ADDENDUM 1

Addendum #	1	**Date Issued**	Nov. 6th, 2026

Project Name | Job #	Bismarck Fire Station 6	20253510

1 G101 FIRST FLOOR LIFE SAFETY PLAN
1/8" = 1'-0"

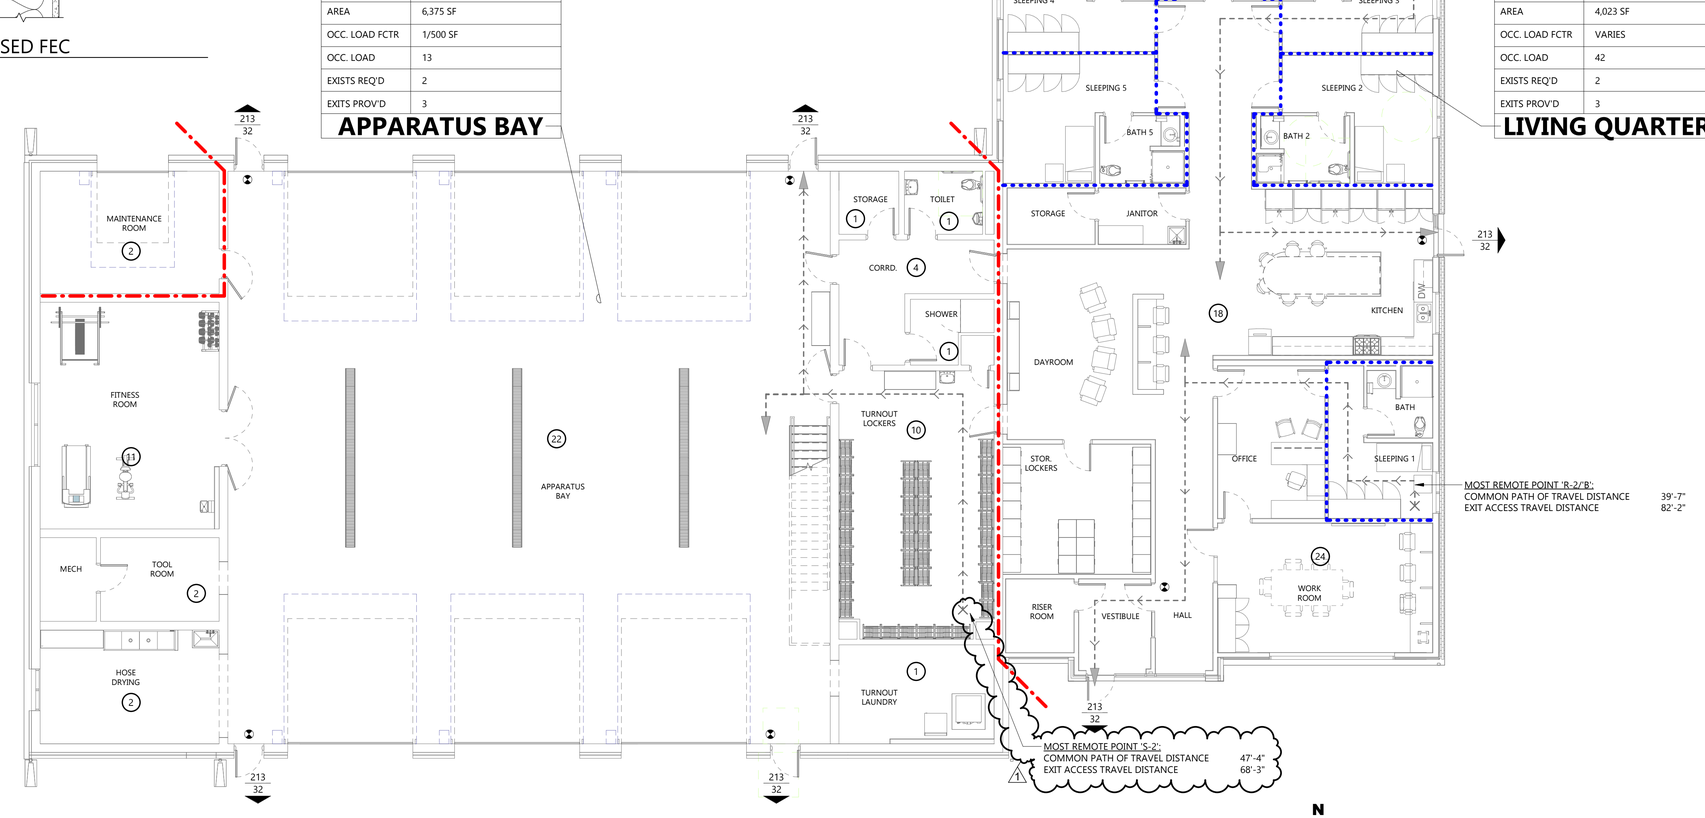
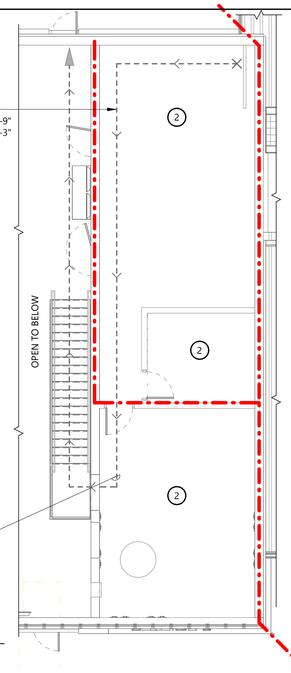
G101	**CLARIFICATION** of information, number of water fountains, and exit distances.
	REMOVE 1-hour fire rating along Mechanical203/Data 202 to Training/Storage 201/Apparatus Bay 128.
S001	**REVISED** Structural general notes.
S002	**REVISED** Design criteria, loads, and material strengths.
S003	**REVISED** Special inspection tables.
S200	**REVISED** Schedules and foundation plan.
S201	**REVISED** Schedules and slab plan.
A001	**REVISED** Fire alarm mounting height.

1 A003 SITE
1" = 20'-0"

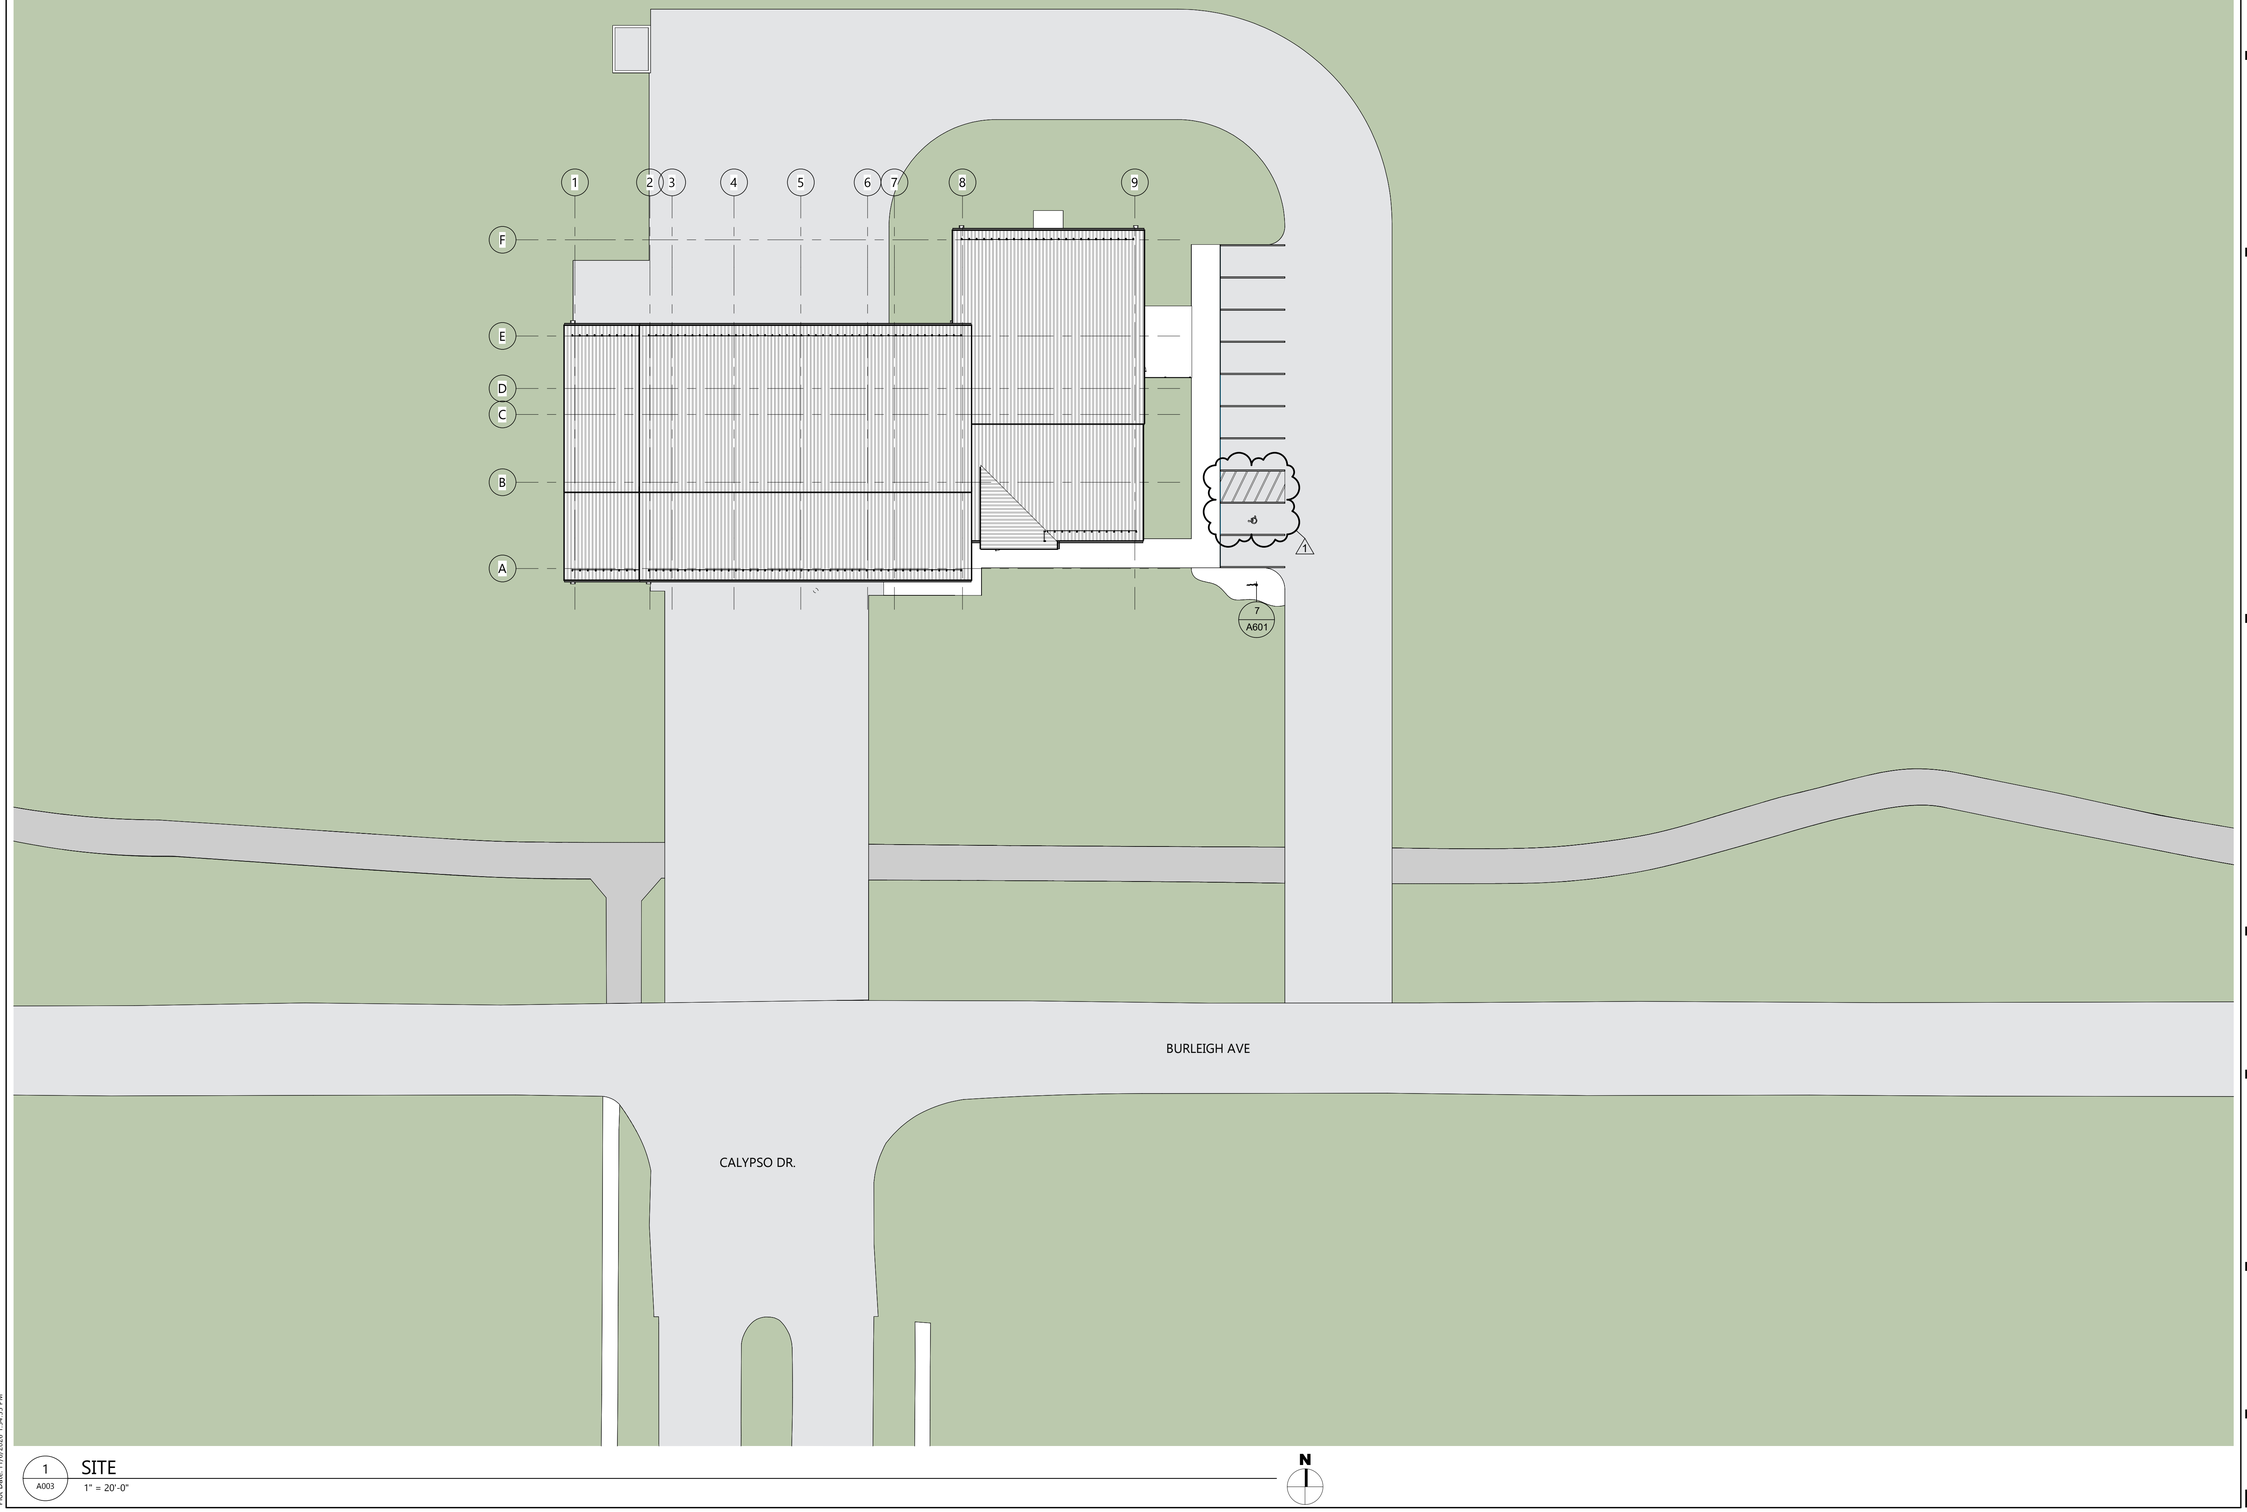
A003	**REVISED** Site plan to show ADA parking.
A021	**REVISED** Wall types E3.1 and E4.1.
A201	**REVISED** First floor plan living quarters walls.
	ADD note to 3/A201, all bollards to receive a plastic bollard cove, typical.
A401	**REVISED** Elevation keynoted for downspouts. Adjustments made to exterior light fixtures.
A441	**CHANGED** Foundation insulation from R-10 to R-15.
A442	**CHANGED** Foundation insulation from R-10 to R-15.
A501	**REVISED** Exterior wall of Living Quarters.
A701	**REVISED** View names updated.
A801	**CLARIFICATION** of door information on door schedule, fire rating, overhead door operator performance, and room name of door location.
	CLARIFICATION of overhead door OHS-SG panel times, relocated bi-fold door frame elevation to Alternate #1 sheet.
A831	**CLARIFICATION** of door information of schedule, frame type and what door within base bid the Bi-Fold/Four-Fold door will replace within Alternate #1.

2 P201 FIRST FLOOR PLUMBING PLAN - 109, 112, 113, 114, 115 & 116

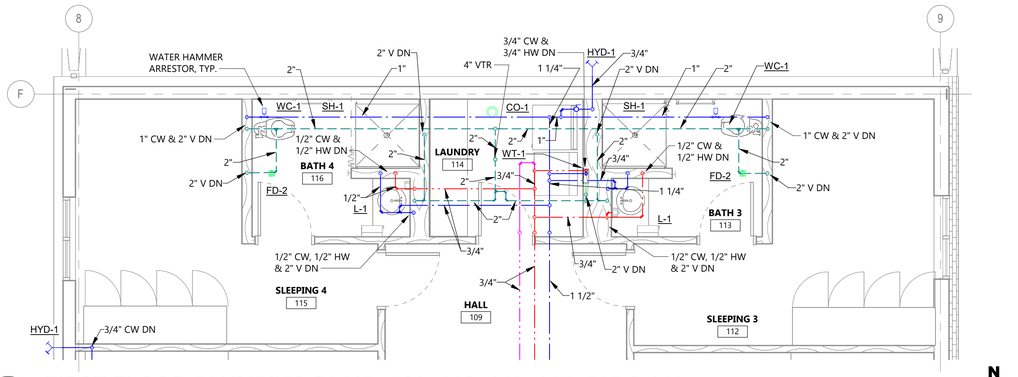
RELOCATED STL-02 door frame from A801.
P201	**ADDED** FD-2 tag in shower 124
P202	(2P202) - **ADDED** FD-2 tag to shower 124
P501	**CHANGED** SH-3 to FD-2 tag on sanitary waste & vent riser
M301	**REVISED** cfm for EF-1 and associated ductwork sizes.
M302	**REVISED** cfm for EF-1 and MAU-1 and associated ductwork sizes.
M801	**REVISED** MAU-1 gpm on mechanical flow diagram
M802	**REVISED** airflow and performances for EF-1, MAU-1 and L-3.
